ADDENDUM NO. 01 (Date: June 27, 2022)

Fairhope Sewer Upgrade Phase I

Bid No. 005-22 – Lift Station Rehabilitation

Project: Lift Station Rehabilitation, ADCNR Grant #S1P25-FSU1

3B

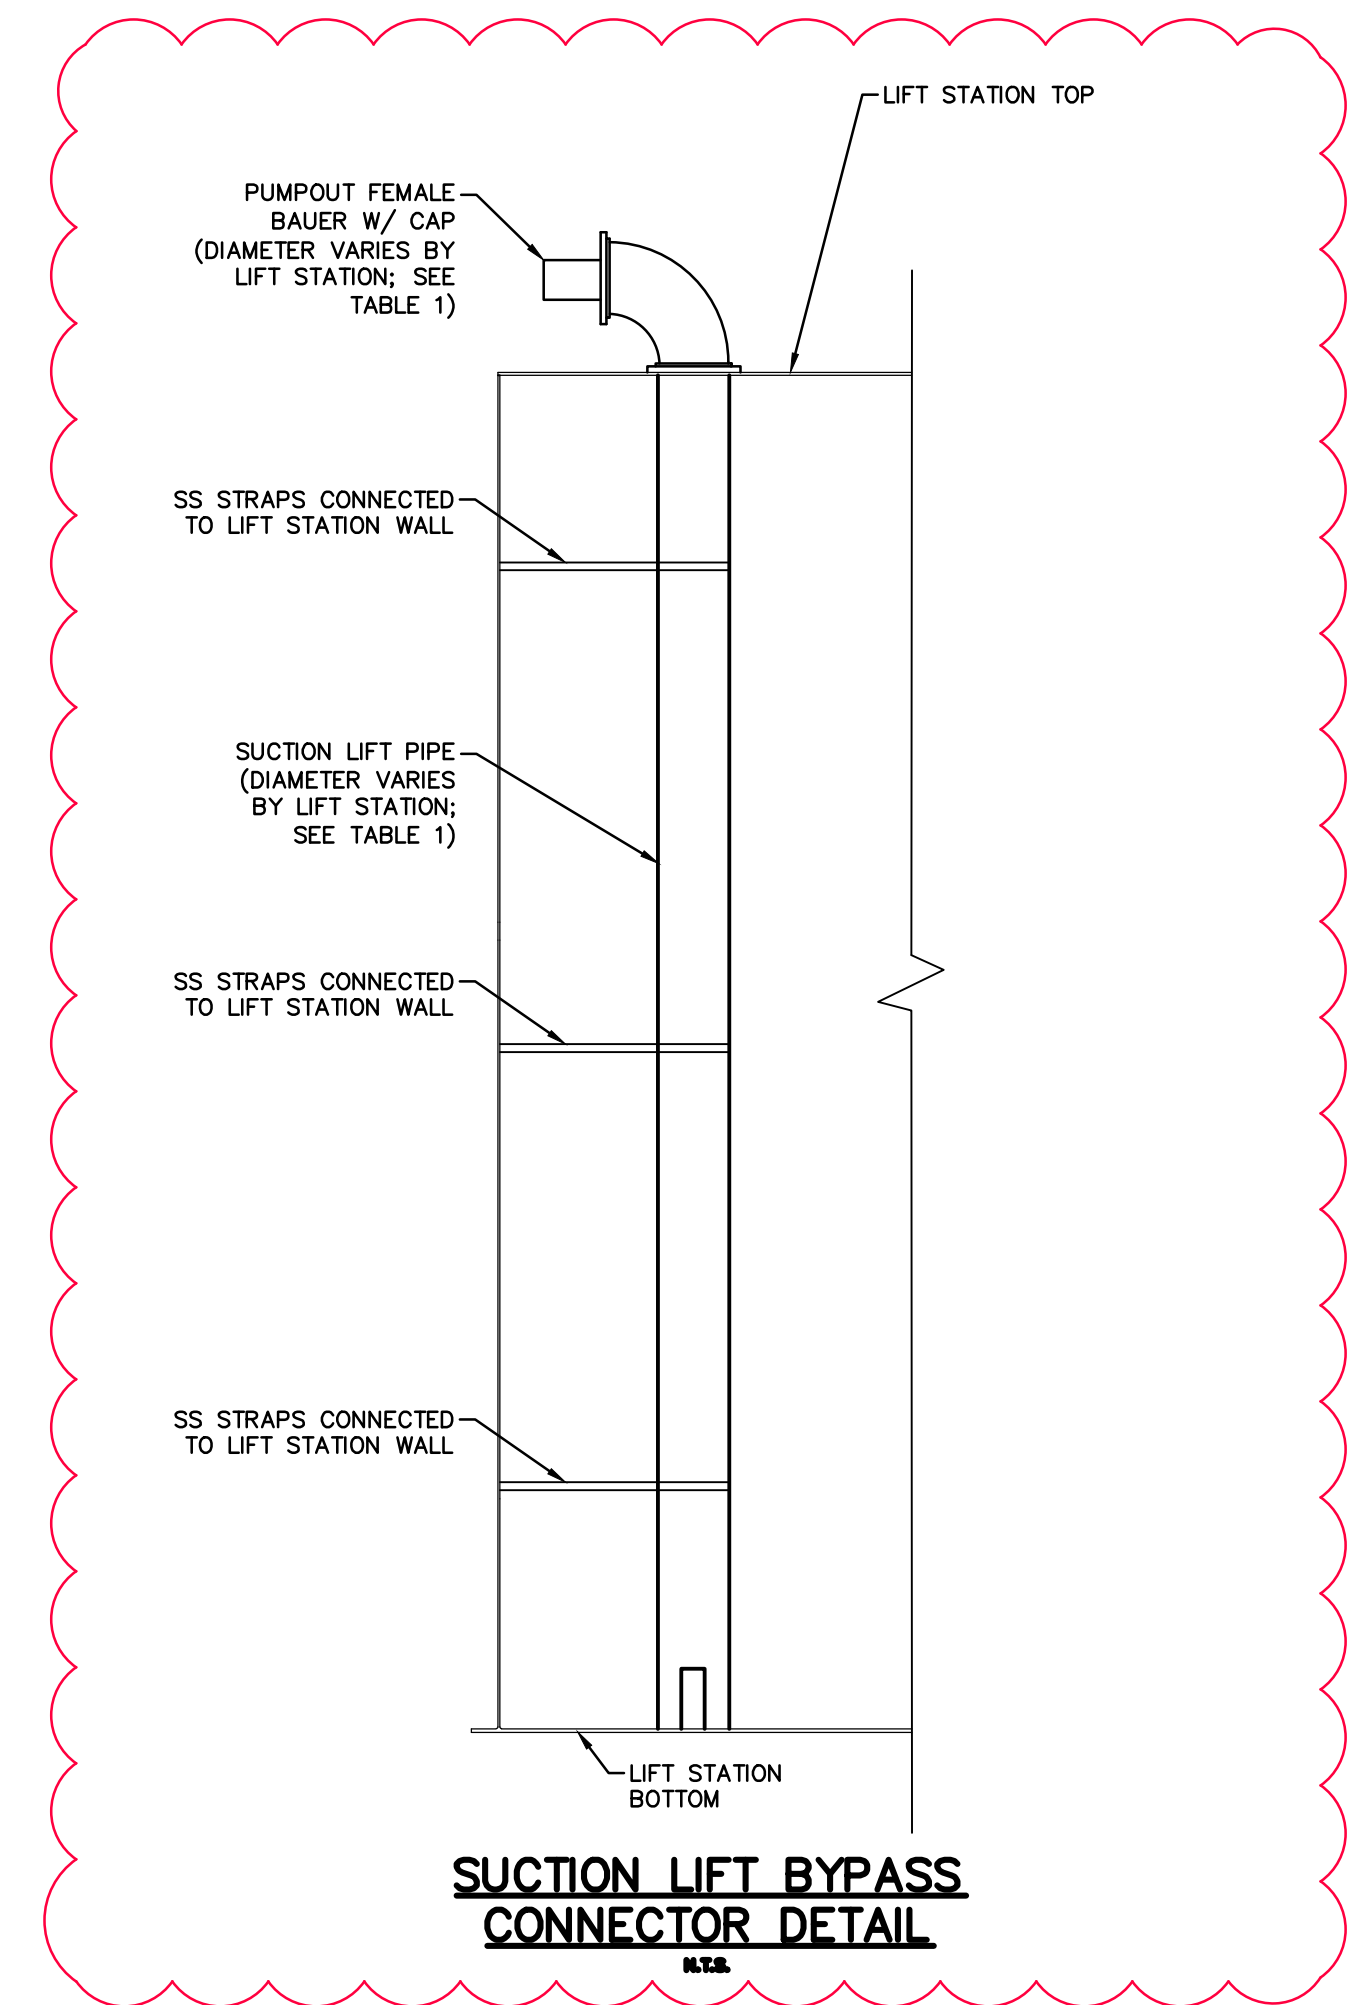
30. **Drawing Amendment:** A suction lift bypass connection detail was added to sheet 3B. Revision is attached with this addendum. This detail will apply to all lift stations. The attached plan sheet will completely replace the previous version (IFB 5/23/22) in its entirety.

ADDENDUM #01
• ADDED SUCTION LIFT BYPASS CONNECTOR DETAIL

LIFT STATION	SUCTION LIFT BYPASS LINE & PUMPOUT FEMALE BAUER DIAMETER (IN.)
NORTH SECTION	6"
SOUTH SECTION	4"
THOMPSON HALL	6"
WHITE GROVE	4"
PIER & MOBILE	6"
NORTH MOBILE	4"
